**Evaluating  
Water Storage Requirements  
for  
Akaroa Treated Wastewater  
Irrigation System**

**Using Actual Flow Data from 2018-2023**

**27 September 2023**

**Dr. Brent Martin  
Data Scientist**

**Figure 1 Storage requirement based on actual flows versus modelled flows<sup>1</sup>**

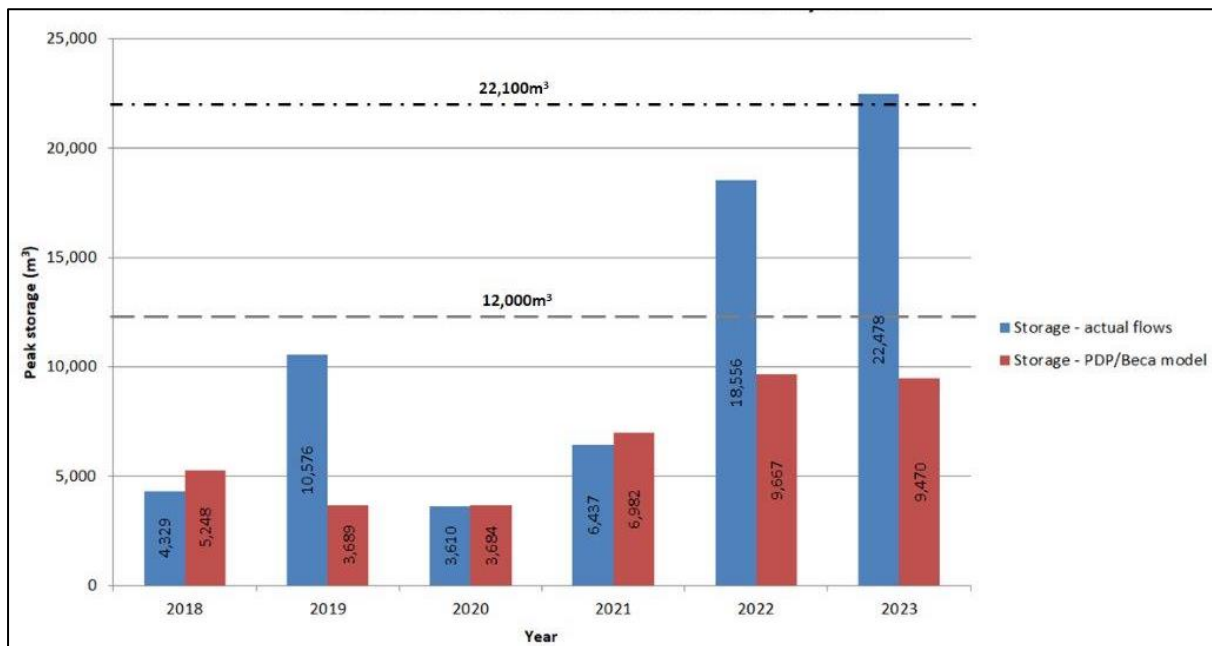
The exercise has revealed that the actual wastewater flows are higher than the predicted flows particularly during wet winters, and that the storage requirements are therefore also much higher. The chart below shows the difference between the storage based on the Beca/PDP estimated flow data and storage based on the actual flows for the 5½ years for which actual flow data is available. This shows that while the consultants' model is reasonably accurate for dry years, it has substantially underestimated the storage requirement in wet years.

A re-evaluation of the long series back to 1972, based on winter rainfall alone and without any provision for population growth but including the proposed I&I and retentate reductions, suggests that the peak storage required would likely be in excess of 25,000m<sup>3</sup>.

**Figure 2 Peak storage requirement 2018 - 2023 based on actual flows**

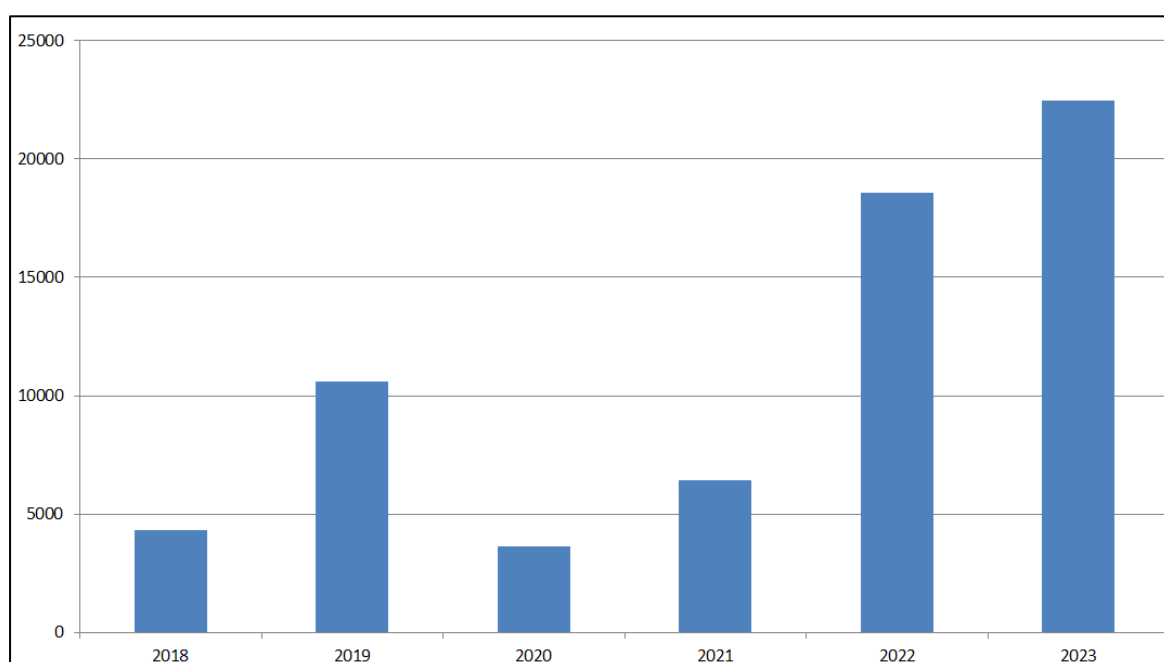
The chart shows that in the years 2018-2021 the 12,000m<sup>3</sup> storage provided would have been sufficient at all times through the year, but in 2022 and 2023<sup>6</sup> it would not.

**Figure 3 Storage based on actual flows versus modelled flows (includes I&I and retentate reductions)**

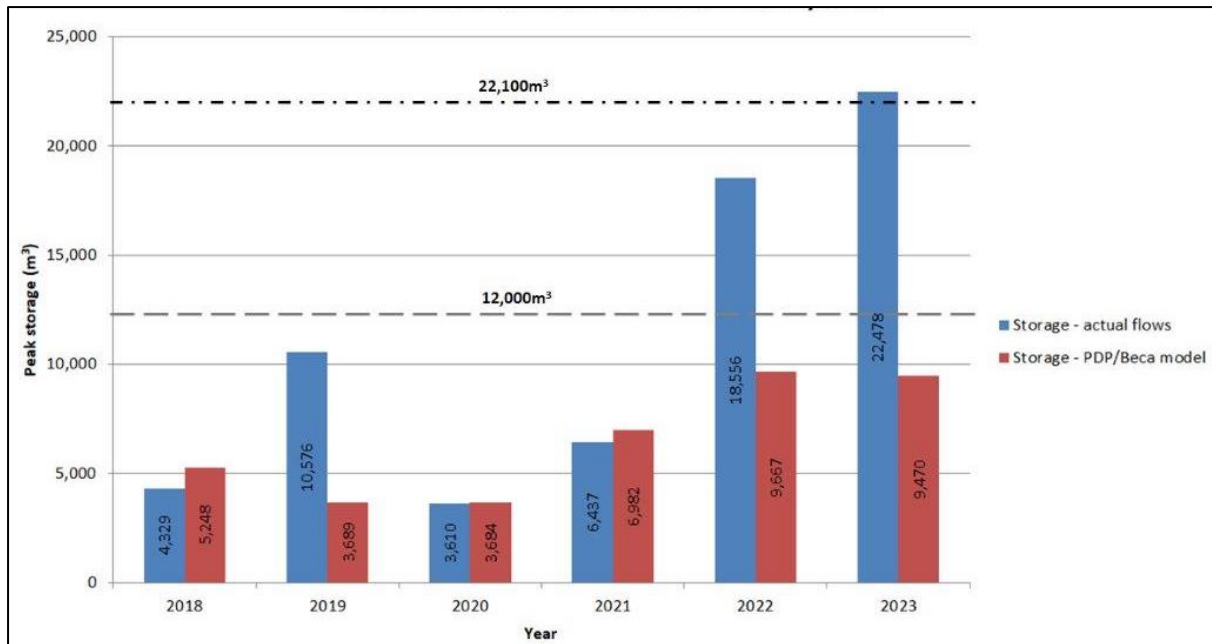
The comparison shows that the model is fairly accurate in 2018, 2020 and 2021 but has significantly underestimated the storage required in 2019, 2022 and 2023 when compared to that required by the actual flows.

**Figure 4 Modelled versus actual Flow for 2022**

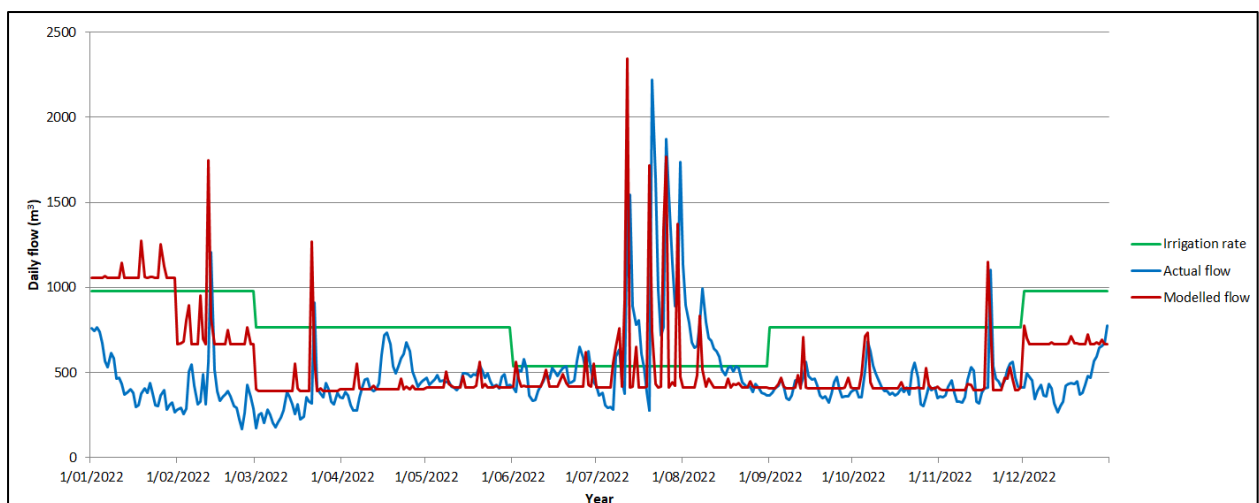
The red Modelled line bottoms out as a flat line reflecting three different levels because the population component of the wastewater flows is estimated in the model using the assumed flows from different future populations for January (894m<sup>3</sup>), December and February (506 m<sup>3</sup>) and March-November (236 m<sup>3</sup>). The blue Actual flow line shows the real fluctuations caused by population changes, with weekend and holiday patterns (such as Easter and Anzac in April) apparent.

Another obvious difference between Modelled flow and the Actual flow is that the Modelled flow shows much higher rates in summer than the Actual flow. This is again attributable to the population flow component, and shows that the population constant provided in the Model for summer (both January and December/February) is higher than was actually present in 2022. However, this does not impact the peak storage requirement – although it is over the green line, 12,000m<sup>3</sup> of storage would accommodate the surplus.

**Figure 5 Modelled versus Actual Flow Winter 2022**

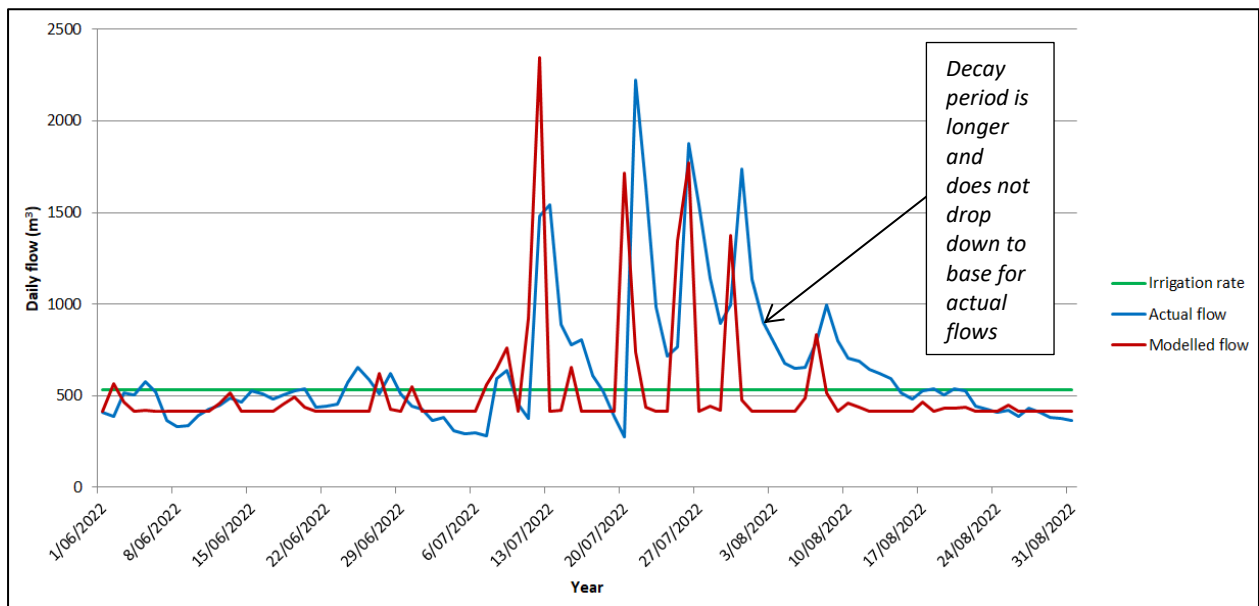
While the rainfall peaks vary in their height, much more significant in terms of the total flow and storage requirement is the decay in these peaks. The red Modelled flow peaks reduce rapidly back to the pre-rainfall level. However, the blue Actual flow shows that RDII (the rainfall infiltration) takes more time to decay than modelled, meaning that the actual amount of water in the system is a significantly greater volume than forecast. It also shows that when several rain events are close together, the amount of RDII increases further as the decay period takes longer. Both of these taken together indicated that the model substantially underestimates the total volume of RDII generated by rainfall events.

It can be inferred from this that the model approach of multiplying every mm of rainfall by the constant of 22.5 cubic metres does not capture the entire RDII response to a rain event - because it does not include the long tail of RDII (the decay period) occurring **after the actual rain event has ceased**. This is most pronounced during wet winters when RDII remains high for longer, as shown by the increasingly long decay period after each subsequent rain even in the graph above. Hence the modelled flow underestimated the RDII.

**Figure 6 Comparison of storage based on actual and modelled flows**

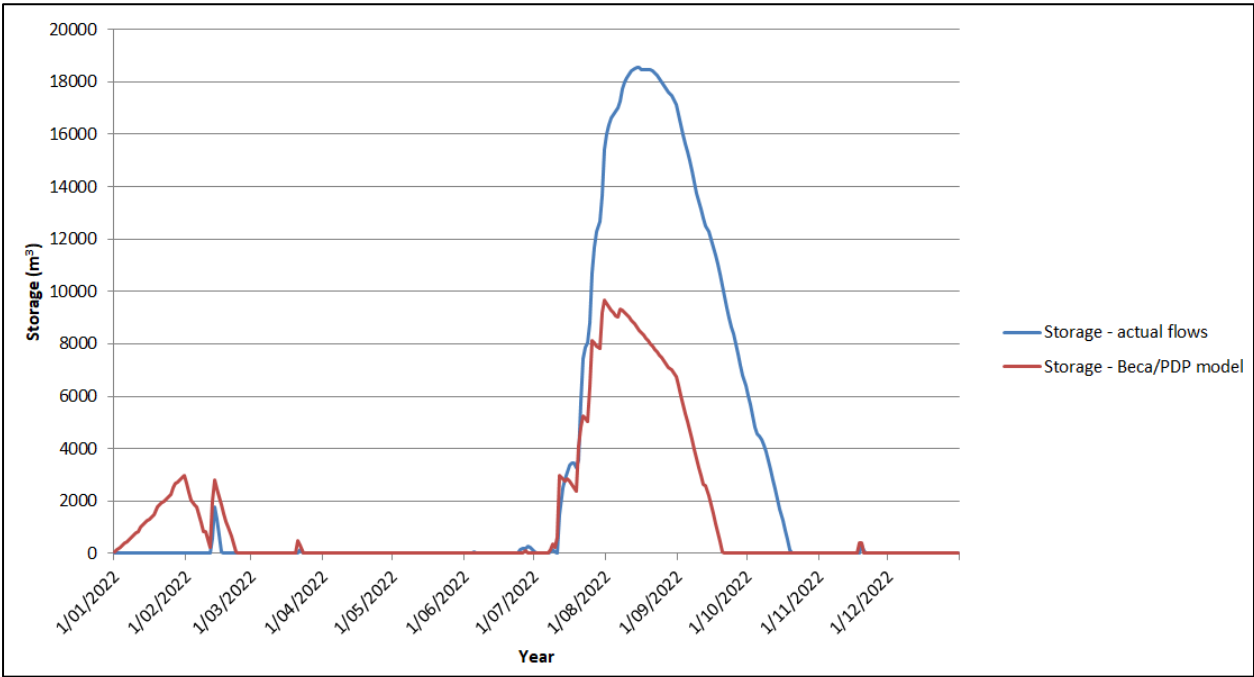
The graph shows the cumulative effect on storage of the greater volume of additional water in the actual flows than the modelled flows. The amount continuously flowing in because of the ongoing greater amount of RDII is much higher than can be irrigated during the ongoing wet period and this rapidly results in a much greater actual storage requirement than has been modelled. This is also evidenced by the patterns - the red line is jagged showing how the modelled storage begins falling immediately after a rainfall event and then climbing again with the next, whereas as the blue line shows, *in reality the storage continues to rise because of the tail of RDII after the rainfall event itself is over.*

Figure 8 Peak storage linear relationship to winter rainfall

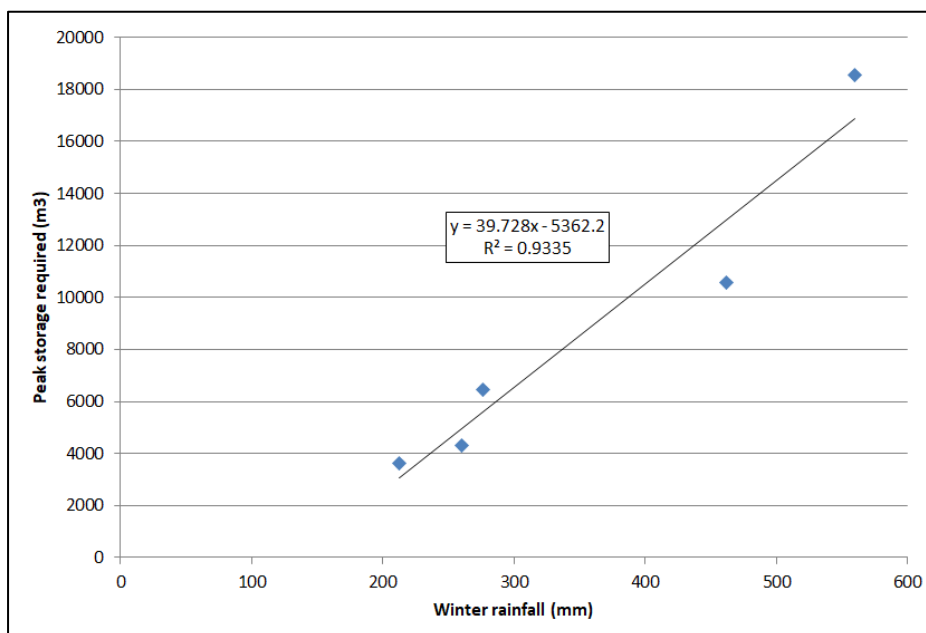
the totals for each year, a linear regression between storage and rainfall was performed. As shown in Figure 8 this confirmed a strong relationship ( $R^2 = 0.93$ ), and a predictive formula of storage being 39.738 times the winter rainfall less 5362.<sup>8</sup>

Figure 9 Peak storage requirements based on winter rainfall 1972-2022<sup>10</sup>

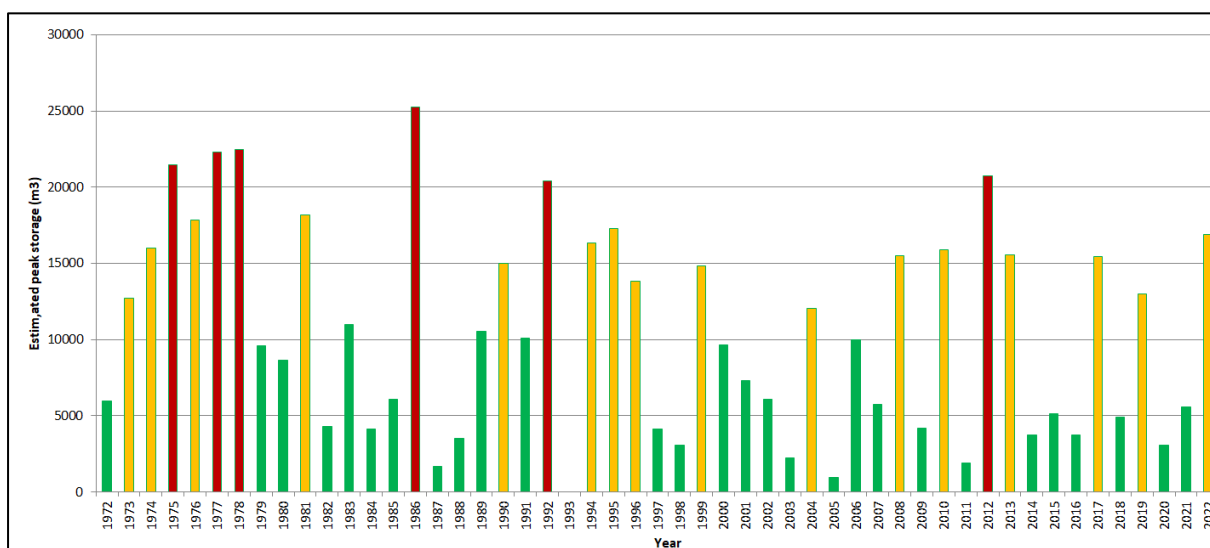
This graph shows that when winter rain alone is used to predict storage, then in 22 of the 51 years more than 12,000m<sup>3</sup> would have been needed, and in 6 years, more than 20,000 m<sup>3</sup>. In the years 1977, 1978 and 1986 the wastewater flow would have exceeded the total storage applied for including the Old Coach Road overflow and, as we have seen already, so would 2023.

1986 has the highest storage requirement, rather than 1978 as identified by PDP, because it has the highest winter rainfall.

Using winter rainfall as the predictor indicates that the long-series storage requirement in the ATWIS application is very likely to have been substantially under-estimated, and that a peak storage requirement in excess of 25,000m<sup>3</sup> is indicated, not 12,000m<sup>3</sup> as in the application.

Figure 10 Peak storage with field size of 35.7ha and 40ha based on actual flows

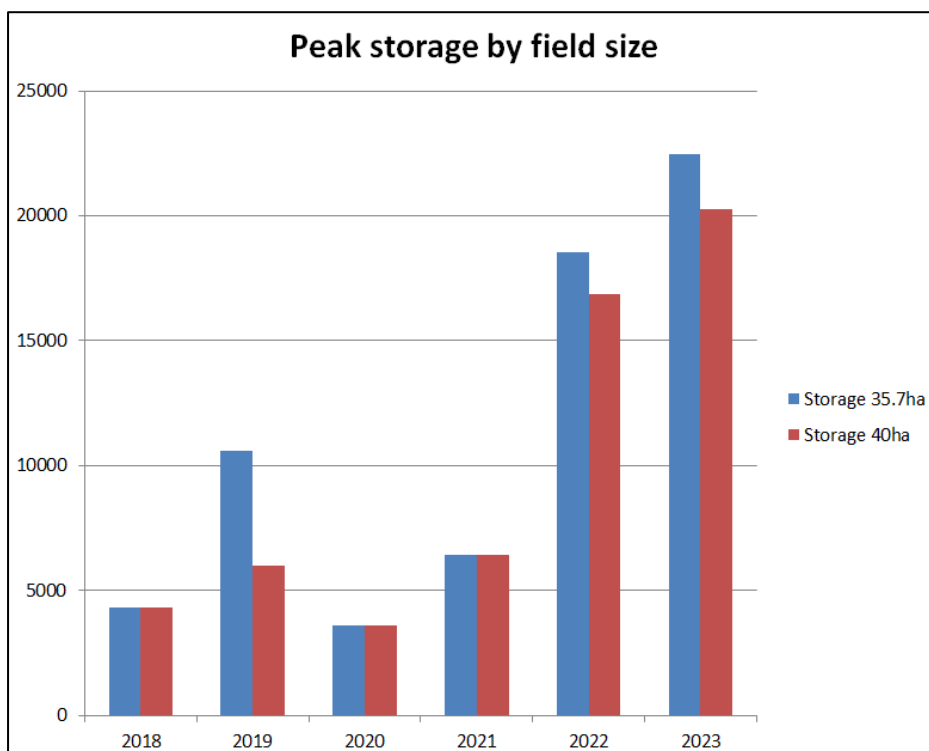
The chart shows that the impact of reducing the field by 4.3ha is only significant in relatively wet years. In years with dry winters where the storage requirement is low, such as 2018, 2020 and 2021, the 35.7ha field irrigation capacity is not reached, so there is no difference in the storage needed. In years with wet winters, when the entire field is needed, the difference is more substantial.

Note that in 2023, even with 40ha, the storage requirement was still more than the 20,000m<sup>3</sup>, and the emergency wetland storage at Old Coach Road would have been required. The reduction of the field size to 35.7ha means that even after filling the emergency 2,100m<sup>3</sup> wetland at Old Coach Road, there would have been an overflow.

Field size makes the biggest difference in 2019, which had a much wetter winter than the adjacent dry years. In the 2019 rainfall pattern, there were relatively few rain events over 50mm that would trigger the ceasing of irrigation. Since it would have been possible to irrigate on most days, a larger field paid off by enabling more water to be disposed of. Conversely, in 2022 and 2023 there is less difference because there were a substantial number of days when the rainfall threshold was exceeded, so regardless of the field size, no irrigation could have taken place and the water would have to go into storage. This illustrates that increasing field size alone is not a substitute for sufficient storage.

**Figure 11 Peak storage requirements for actual flows with reduction scenario comparison**

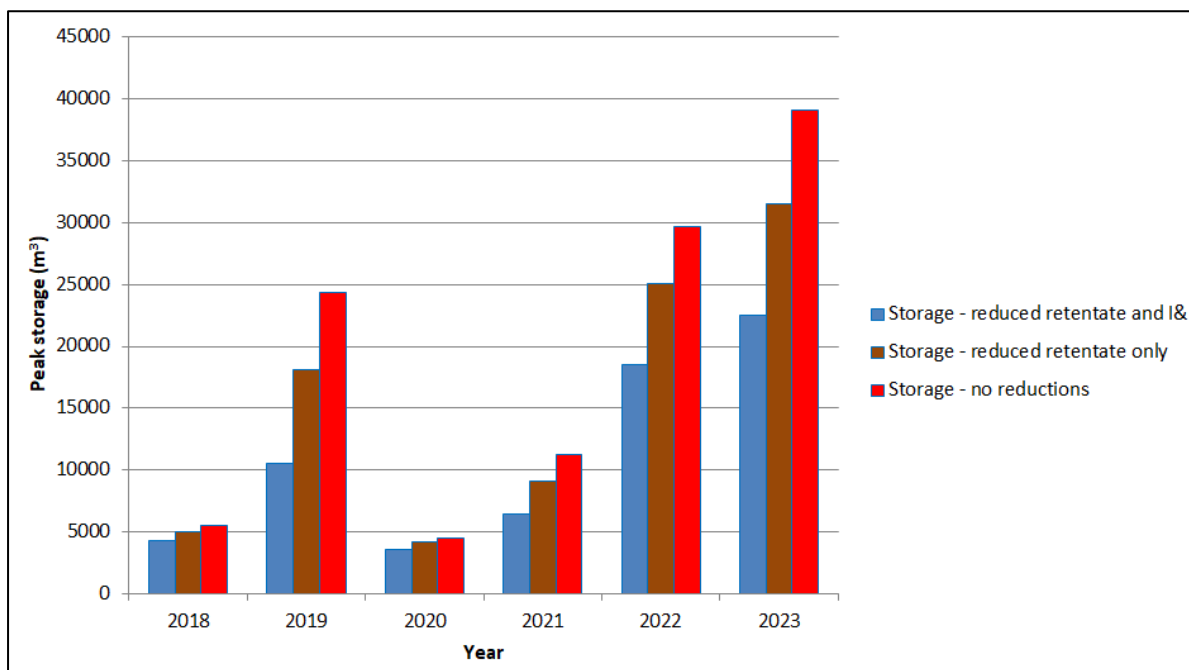
What this exercise demonstrates is how critical the I&I and retentate reductions are to the peak storage requirements. Without these reductions, the storage volumes in wet years are much higher and by the end of July 2023 (the wettest winter in the 5½ years of actual flow data), 39,098m<sup>3</sup> of storage would have been required.
